Access Compliance Report

Public Rights-of-Way

Intersection ID: 28305	Main Street: COMMUNITY_HOUSE_RD	Cross Street: TAMARACK_DR	Location: NW
ADA ID: 62EAA274725E	Ramp Type: Perp	Initial Pass/Fail: Fail	Overall Compliance: No
		Severity Score: 12.5

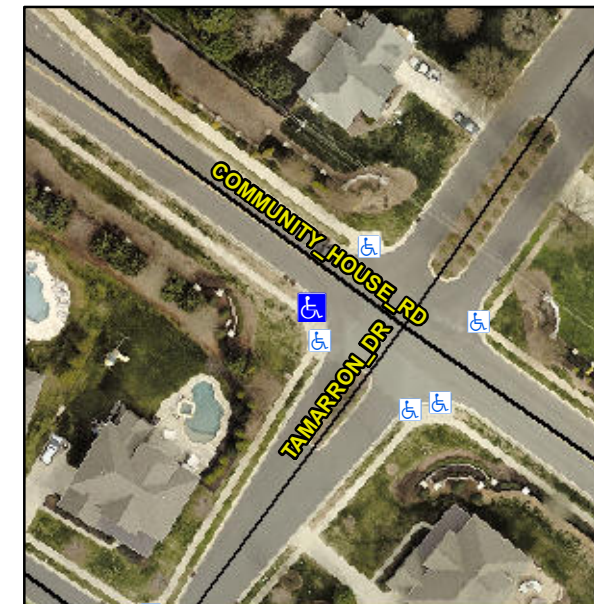
Not Found, R304.5.3

Compliance	Description	Data	Compliance	Description	Data
N/A	Ramp Length (in)	69.0	Yes	Ramp Slope (%)	6.7
Yes	Ramp Width (in)	48.0	No	Ramp XSlope (%)	6.3
N/A	Flare Type LT	N/A	N/A	Flare Type RT	N/A
N/A	Flare Slope LT (%)	N/A	N/A	Flare Slope RT (%)	N/A
N/A	Flare Traversable LT?	N/A	N/A	Flare Traversable RT?	N/A
N/A	Landing Length (in)	N/A	N/A	DWS Provided?	N/A
N/A	Landing Width (in)	N/A	N/A	DWS Contrast?	N/A
N/A	Landing Slope (%)	N/A	N/A	DWS Length (in)	N/A
N/A	Landing X Slope (%)	N/A	N/A	DWS Full Width?	N/A
N/A	Landing Curb? (Y/N)	N/A	N/A	DWS Offset (in)	N/A
N/A	Shared Landing?	N/A			
N/A	Gutter Ponding?	N/A	N/A	Gutter Slope (%)	N/A
N/A	Gutter Lip Ht (in)	N/A	N/A	Gutter X Slope (%)	N/A
N/A	Painted X Walk1?	No	N/A	Painted X Walk2?	N/A
	X Walk 1 Direction	To NE		X Walk 2 Direction	N/A
N/A	X Walk 1 Width (in)	N/A	N/A	X Walk 2 Width (in)	N/A
	X Walk 1 Slope (%)	11.1		X Walk 2 Slope (%)	N/A
	X Walk 1 X Slope (%)	0.2		X Walk 2 X Slope (%)	N/A

Remove & Replace Entire Ramp.
